FROM: Service Systems Development

SUBJECT: **DD Heavy Duty Platform Belt Tensioner Change**

Fig. 2, New Friction Damping Tensioner

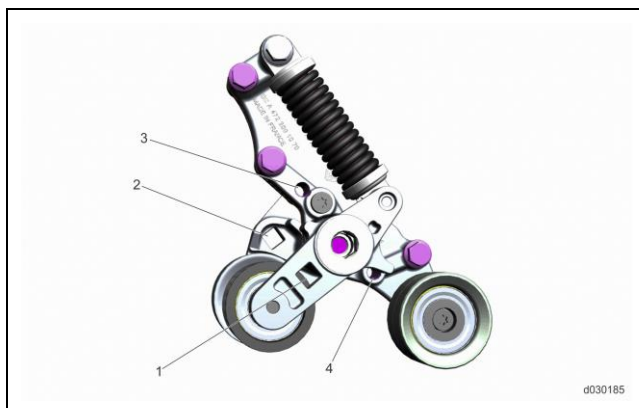
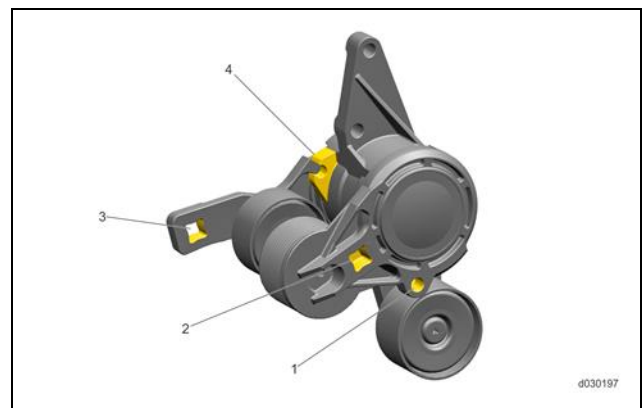
A newly designed, dual-arm friction shoe damping tensioner was implemented for the DD Heavy Duty Platform. New tensioner P/N: A4722001370 was released to engine production on December 7th, 2018, with approximate engine serial number HDE0644305 for current USA/Canada and export engines. Belt lengths and maintenance interval per application and engine variance did NOT change. For current belt information, reference Technical Service letter 18 TS-4rev. New sections in the appropriate workshop and troubleshooting manuals have been created. The new sections are labeled “Friction Belt Tensioner”. The tensioner should only be replaced if indicated by the appropriate troubleshooting manual procedure.

The new friction damping tensioner is not backwards-compatible with certain vehicles built before November 1, 2017. The new tensioner can be used in all vehicles built on or after November 1, 2017. Certain vehicles built before November 1, 2017 will use a different aftermarket friction damping tensioner, part number GT 38667. Refer to Chart 1 for part numbers.

Note: The new friction damping tensioner, P/N A4722001370 and the aftermarket tensioner, P/N GT 38667 are not interchangeable. Tensioner GT 38667 should not be used on vehicles built after November 1, 2017.

Selecting the incorrect tensioner may prevent proper installation due to interference between the tensioner and the fan clutch. This interference may be difficult to identify visually.

Fig. 9, Friction Damping Tensioner Enhancement Description

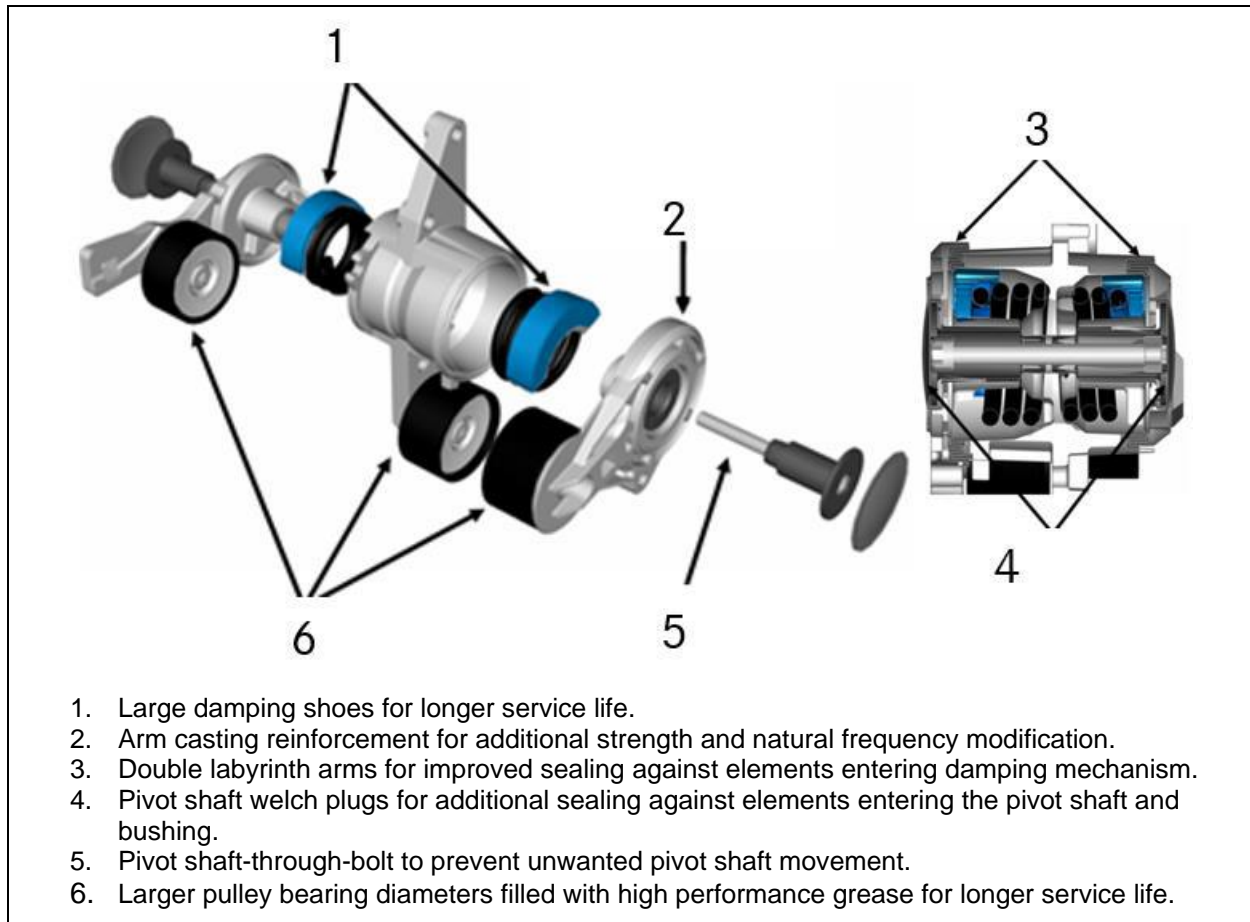
Detroit™ recommends using the new friction damping tensioner, **when applicable and according to Chart 1**. The new belt tensioner has been through vigorous testing to optimize functionality and reliability. The following components have been optimized for the new friction damping tensioner.
